**D4151-041 BASKET FWD HARDPOINT ASSY (LOWER)**

**D4151-043 BASKET FWD HARDPOINT ASSY (UPPER)**

DRAWING NO. **D4151** REV. C  
SHEET 1 OF 3

TITLE **BASKET FWD HARDPOINT** SCALE  
NTS

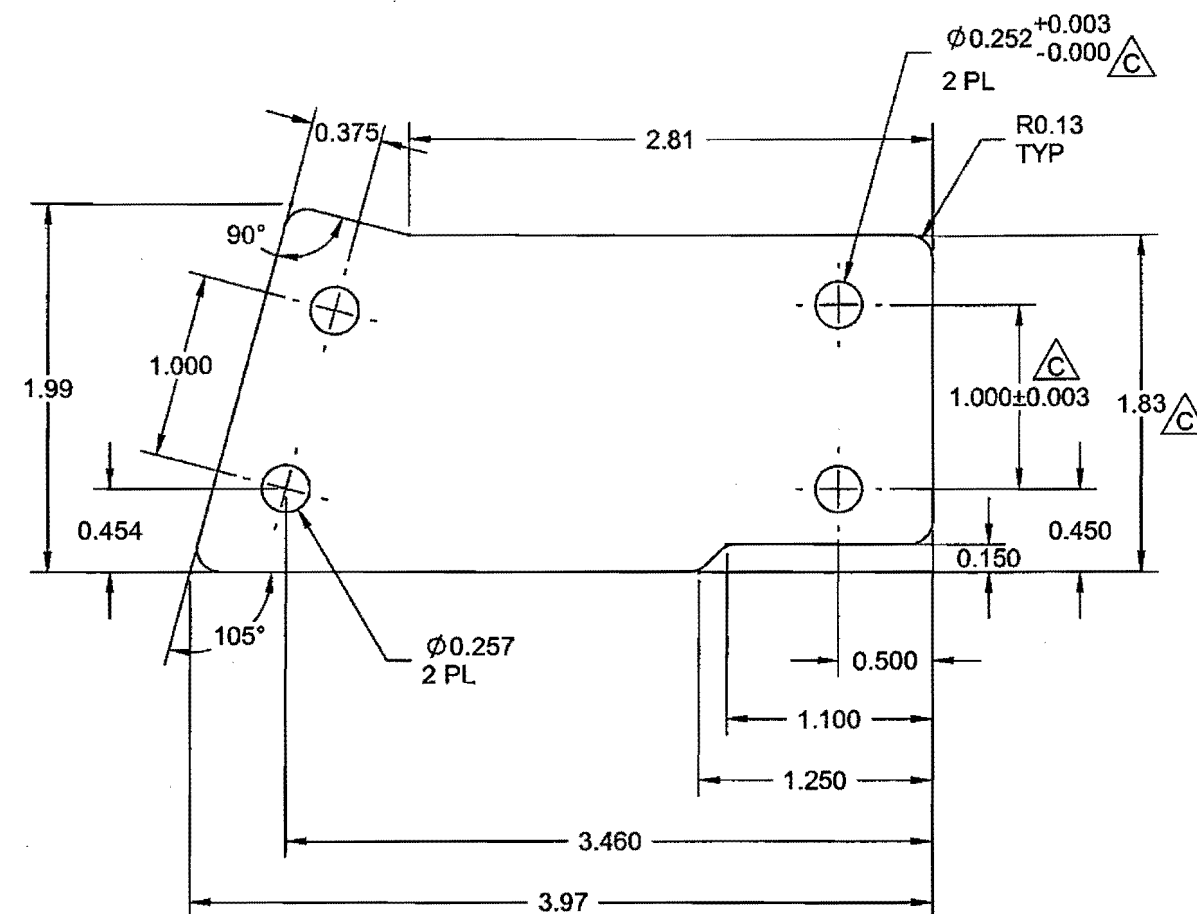
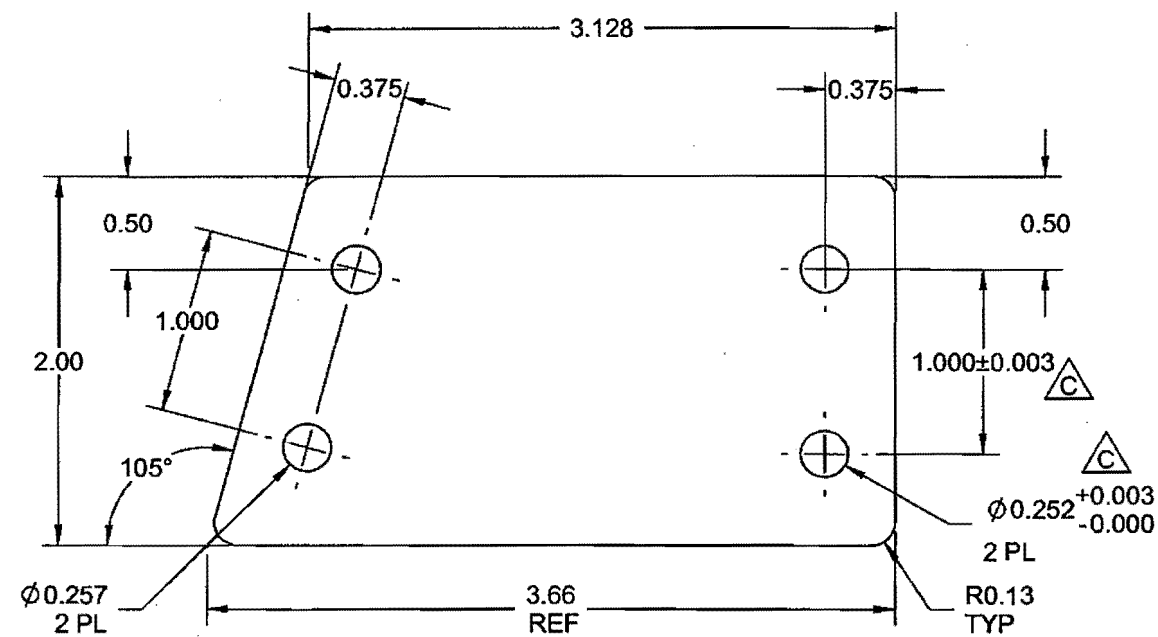
C	AN4 HARDWARE WAS AN3 (B6-1, C3-1 & D3-1); $\phi 0.252$ WAS $\phi 0.191$ (C5-2, D1-2); TIGHTENED TOL ON 1.000 DIM (C5-2, D1-2, C7-3, C3-3); $\phi 0.250$ WAS $\phi 0.191$ (C6-3, B4-3); 1.83 WAS 1.75 (C1-2), 2.84 WAS 2.76 (B3-3) AND 1.88 WAS 1.80 (C1-3) TO PRESERVE 1.5ED. REASON: SEE D407-797 DESIGN JOURNAL.	MB	10.12.14
B	ADDED D4151-5/-7 (SHT 3); D4151-5 WAS D3911-1 (ZN B6-1 & D3-1); D4151-7 WAS D3911-3 (ZN C4-1 & D3-1) ITEMS #5, 6 & 7 REPLACE MS20615-4M20 (ZN C3-1, D3-1 & B8-1); $\phi 0.191$ 2 PL REPLACES $\phi 0.129$ 3 PL (ZN C5-2); $\phi 0.191$ 2 PL REPLACES $\phi 0.129$ 4 PL (ZN D1-2). REASON: SEE TR-D350-607-2 REV. B.	MB	10.07.05
A	NEW ISSUE	MB	10.06.22
REV.	DESCRIPTION	BY	DATE
DESIGN			
DRAWN			
CHECKED			
MFG. APPR.			
APPROVED			
DE APPR.			
DATE	10.12.14
